**FILE** P.I. #222285-
HPPNF-0540-00(029)
Washington County
SR 24/SR 540 Widening from CR 10/CR 342 to West of SR 68

**SUBJECT** **APPROVED REVISED CONCEPT REPORT**

# DEPARTMENT OF TRANSPORTATION
# STATE OF GEORGIA
# REVISED PROJECT CONCEPT REPORT

# REVISED PROJECT CONCEPT REPORT

**Project Sketch Map**

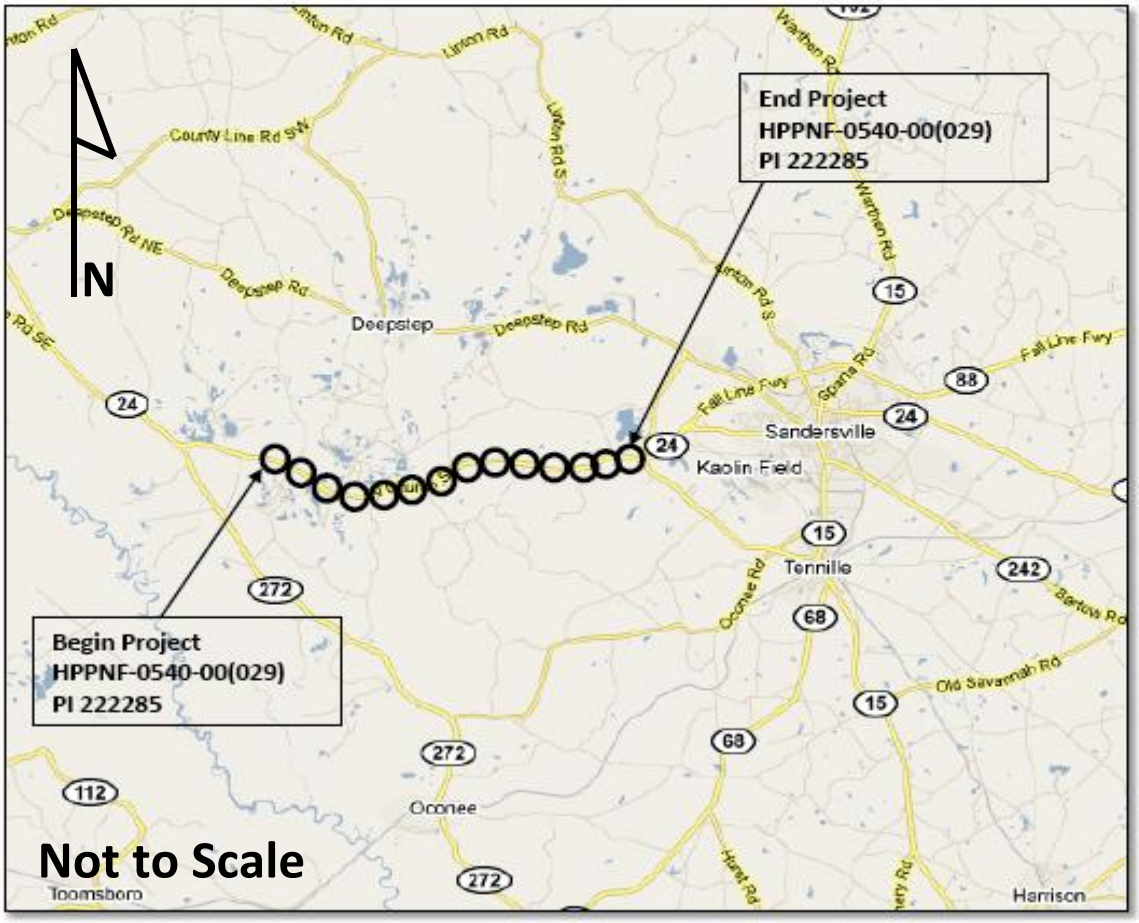
| Approved Features: | Proposed Features: |
|---|---|
| 1. *PROJECT LIMITS:* *Currently, the project extends from CR10/CR342 (Indian Trail Road) east to just west of SR 68.* | 1. *PROJECT LIMITS:* *It is proposed that the project should begin at a point just west of CR10/CR342/Indian Trail Road (MP 30.61 and end just west of SR 68 (MP 22.15). This change would extend the beginning project limits westward 2900 feet.* |
| 2. *MEDIAN WIDTH:* *Currently, a 44-foot median is maintained throughout the entirety of the project.* | 2. *MEDIAN WIDTH:* *It is proposed that the median should be narrowed in width from 44-foot to 32-foot for a length of approximately 3600 feet at the beginning of the project.* |

*Since the completion of the original concept report, several kaolin pits have been mined in the area adjacent to the proposed route at the beginning of the project. In order to avoid these pits, it is recommended that the project be realigned in this area. In order to tie this realigned route into the existing SR24, the beginning project limits must be extended approximately 2900 feet to milepost 30.61.*

*Furthermore, it is also recommended to reduce the median width in the area affected by this shift approximately 3600 feet at the beginning of the project from 44-feet to 32-feet to further minimize any conflicts with adjacent kaolin mine pits.*
